The Fertilizer Institute

TFI Comments to Public Posting on VCS of Michigan State University and EPRI N₂O Methodology

Figure 1. The relationship of N₂O emissions vs fertilizer N determined for the data from Québec-Ontario (n=72).

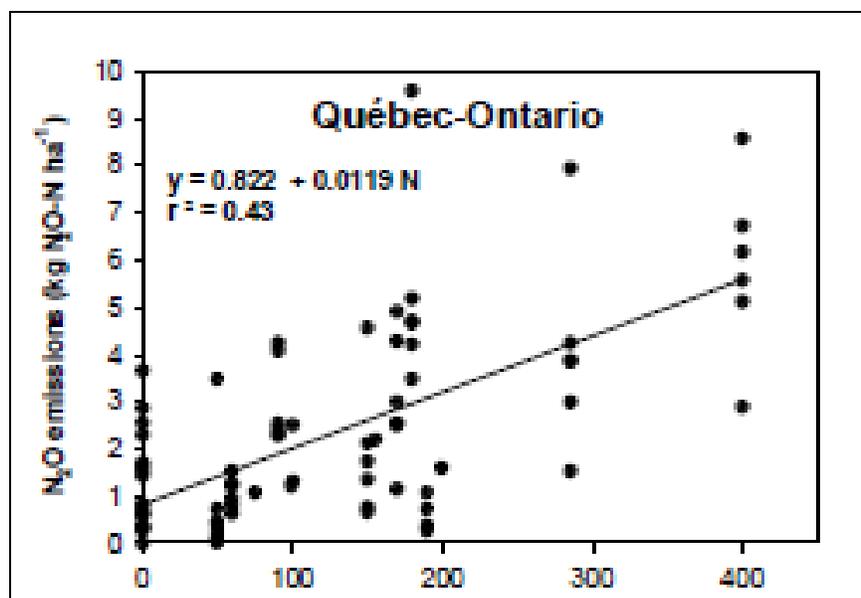
The empirical basis of the Method 2 is data from 8 site-years of data, spanning 2 calendar years from 5 sites. Of these sites, 3 sites are in one Major Land Resource Area (MLRA)², and the other 2 sites in MLRA’s bordering the first. In contrast, the Tier 2 linear equation of Rochette *et al.* (2008) for Québec-Ontario is based on 72 observations from across this climatic region (Figure 1).

Further, the developers of the posted Methodology report the non-linear response curve used in Method 2 results in more emissions, and consequently more offsets generated, than a Tier 1 approach. In contrast, Rochette *et al.* (2008) report:

The “N₂O emissions vs fertilizer N” relationship determined for the Québec-Ontario region (Figure 1) had a slope (0.0119 kg N₂O-N kg N⁻¹) similar to the original (0.0125 kg N₂O-N kg N⁻¹) and the revised (0.01 kg N₂O-N kg N⁻¹) IPCC Tier I default EFs.

The claim of the posted Methodology that Method 2 represents a science-based Tier 2 approach to quantify the N₂O emissions for the North Central Region is not consistent with the good practice guidance provided by the Tier 2 method used in Canada’s National Inventory Report.
